# Access Compliance Report

## Public Rights-of-Way

Intersection ID: 45063	Main Street: ESCAFLOWNE_AV	Cross Street: REDDING_GLEN_AV	Location: SE
ADA ID: 1256FD9D1989	Ramp Type: PerpDiag	Initial Pass/Fail: Fail	Overall Compliance: No
		Severity Score: 10

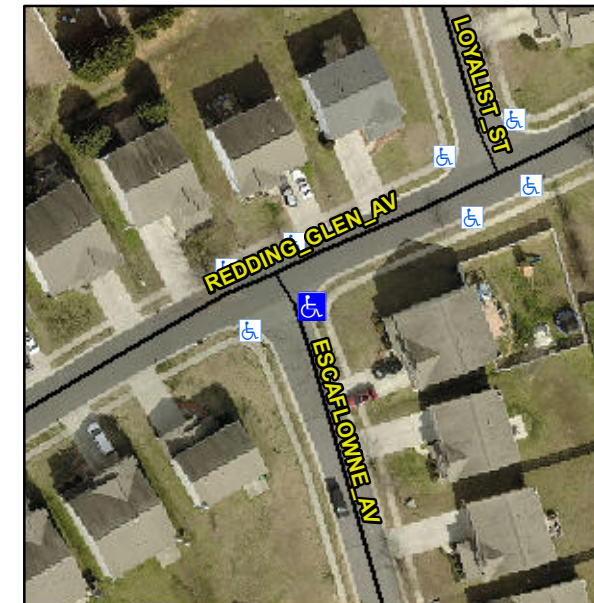
**Not Found, R304.5.1, R304.5.3**

Compliance	Description	Data	Compliance	Description	Data
N/A	Ramp Length (in)	46.5	Yes	Ramp Slope (%)	6.8
No	Ramp Width (in)	47.0	No	Ramp XSlope (%)	2.8
N/A	Flare Type LT	N/A	N/A	Flare Type RT	N/A
N/A	Flare Slope LT (%)	N/A	N/A	Flare Slope RT (%)	N/A
N/A	Flare Traversable LT?	N/A	N/A	Flare Traversable RT?	N/A
N/A	Landing Length (in)	N/A	N/A	DWS Provided?	N/A
N/A	Landing Width (in)	N/A	N/A	DWS Contrast?	N/A
N/A	Landing Slope (%)	N/A	N/A	DWS Length (in)	N/A
N/A	Landing X Slope (%)	N/A	N/A	DWS Full Width?	N/A
N/A	Landing Curb? (Y/N)	N/A	N/A	DWS Offset (in)	N/A
N/A	Shared Landing?	N/A			
N/A	Gutter Ponding?	N/A	N/A	Gutter Slope (%)	N/A
N/A	Gutter Lip Ht (in)	N/A	N/A	Gutter X Slope (%)	N/A
N/A	Painted X Walk1?	No	N/A	Painted X Walk2?	No
	X Walk 1 Direction	To N		X Walk 2 Direction	To W
N/A	X Walk 1 Width (in)	N/A	N/A	X Walk 2 Width (in)	N/A
	X Walk 1 Slope (%)	3.4		X Walk 2 Slope (%)	1.2
	X Walk 1 X Slope (%)	2.3		X Walk 2 X Slope (%)	2.8

**Remove & Replace Curb Ramp With Two New Directional Ramps or Equivalent.**
